MODERNIZATION AT  
 CURRAN MIDDLE  
 SCHOOL  
 FOR:  
 BAKERSFIELD  
 CITY SCHOOL  
 DISTRICT  
 1116 LYNNIC WAY  
 BAKERSFIELD  
 CALIFORNIA  
 93309

MARK	DATE	DESCRIPTION
SD		
CD		
△	06/29/07	ADDENDUM 1
△	06/11/07	ADDENDUM 2
△	11/01/07	ADDENDUM 3

**EXTR ELVS**  
 BUILDINGS E, F, G & H  
 SHEET IDENTIFICATION NUMBER  
**A-223**  
 SHEET 18 OF 46

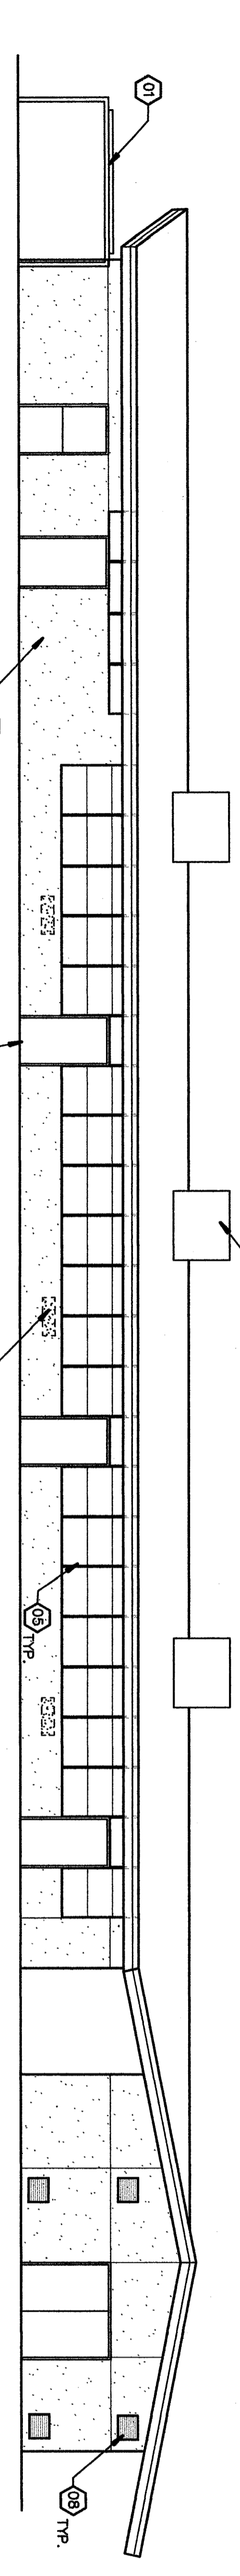
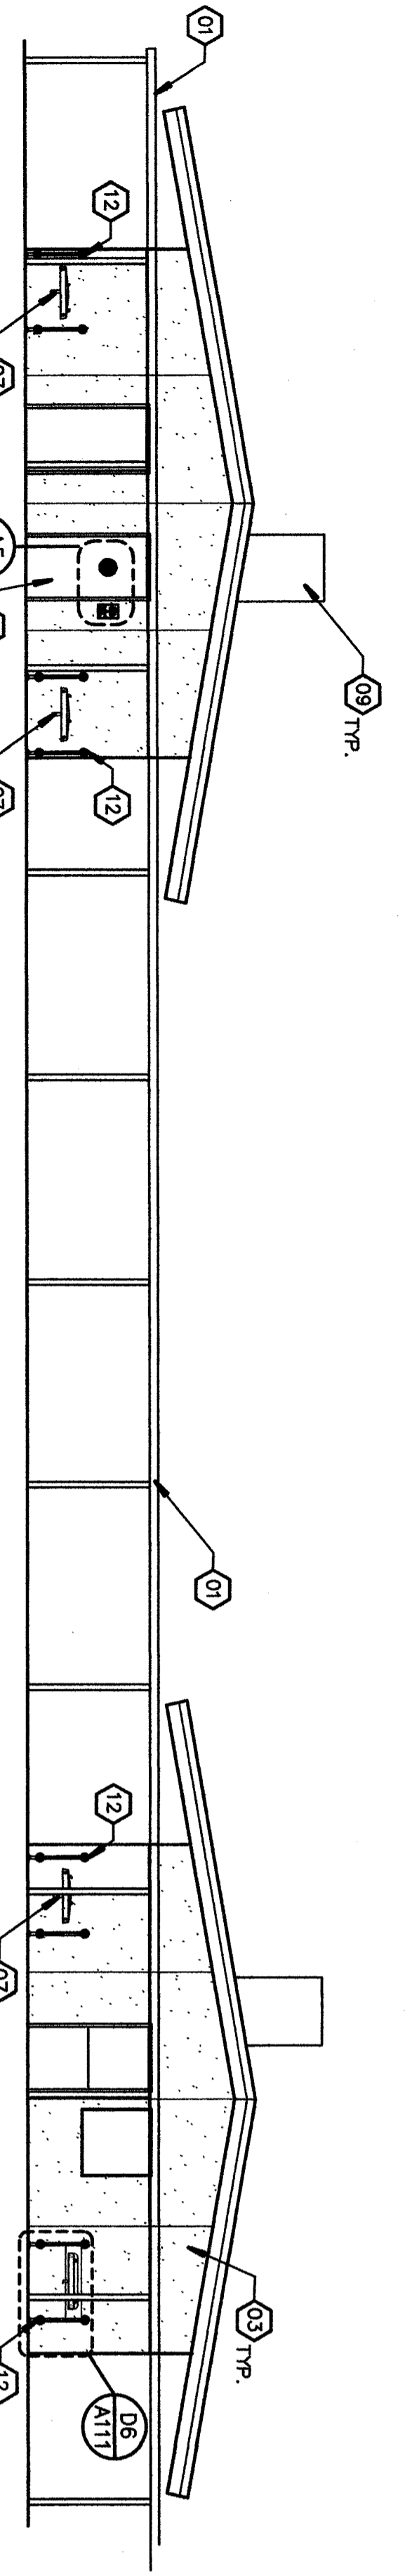
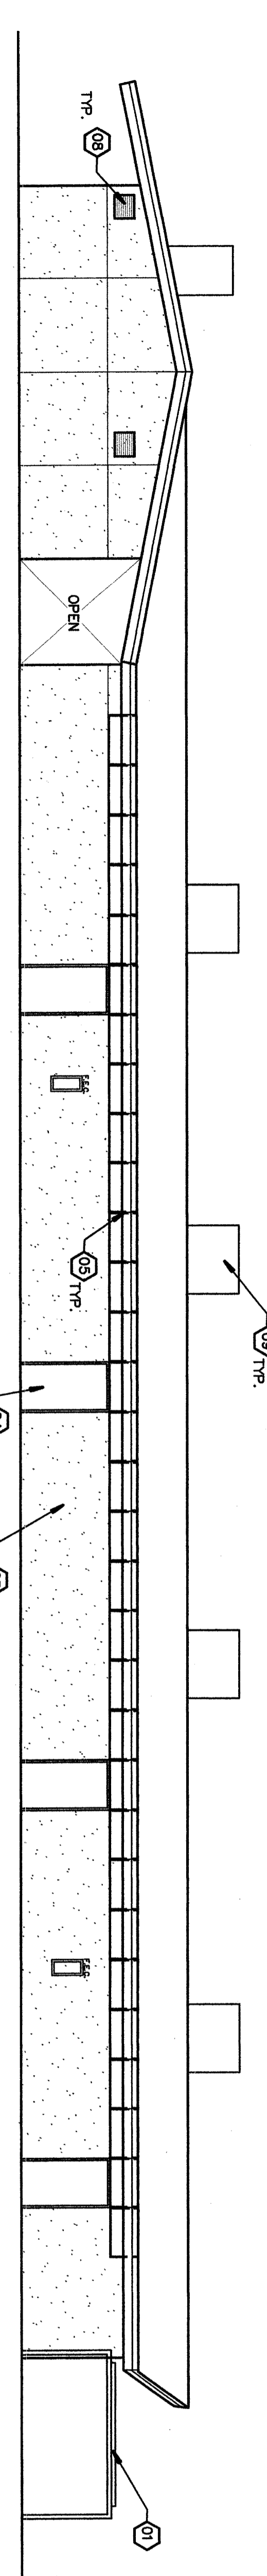
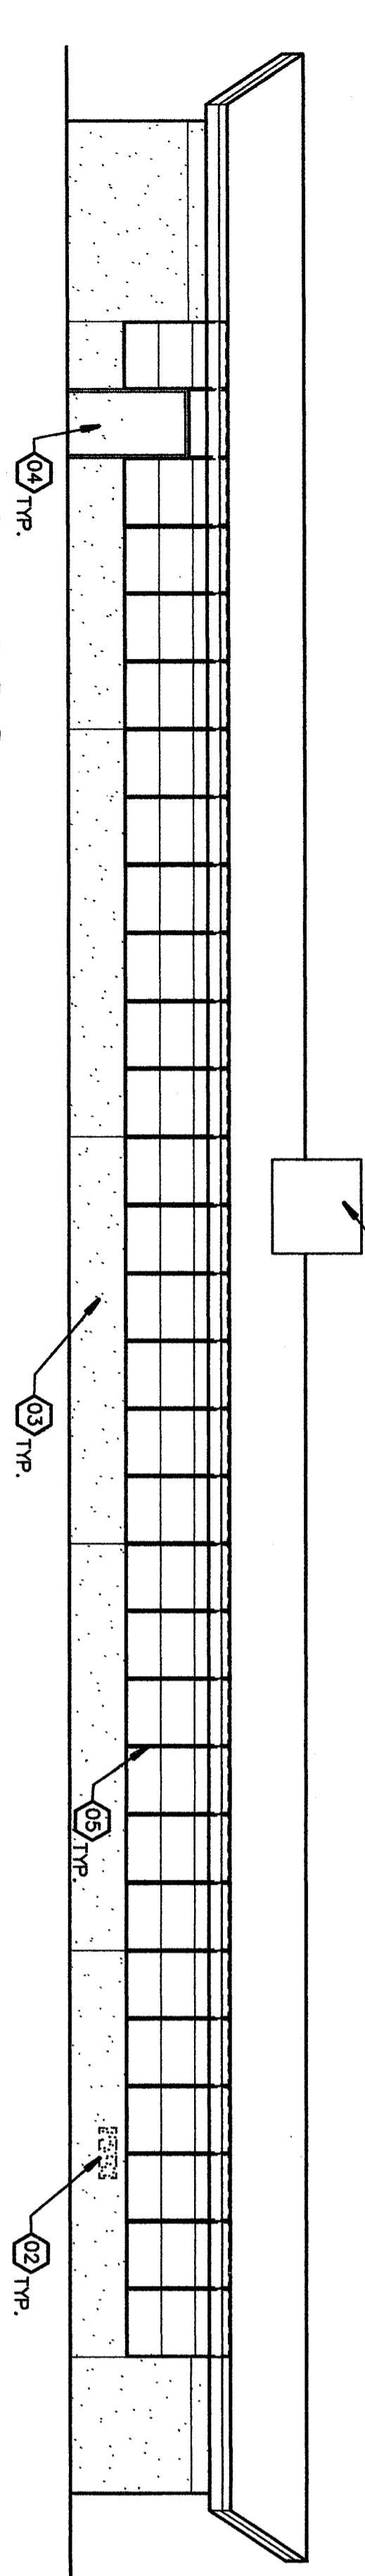
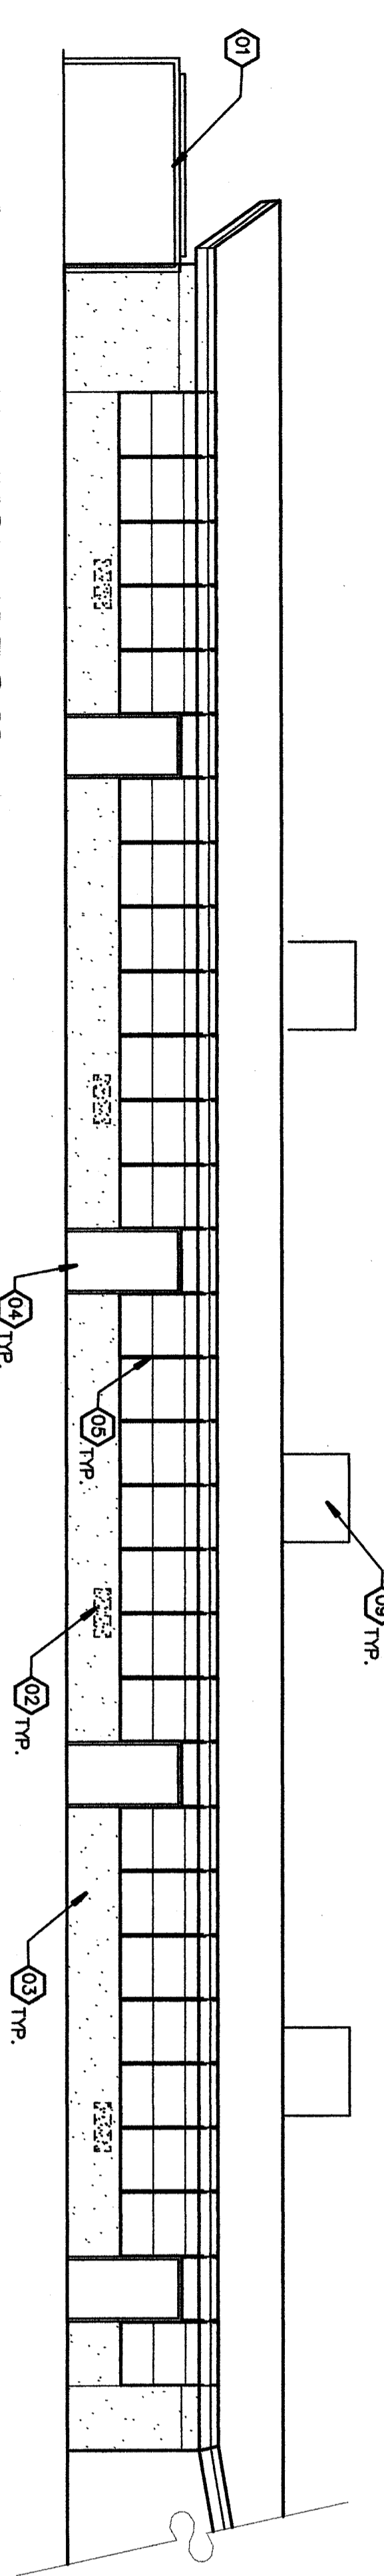
Item No. 7: Refer to Sheet A-223  
 Remove Keynote 01 to read. Existing covered walk to be removed by others.
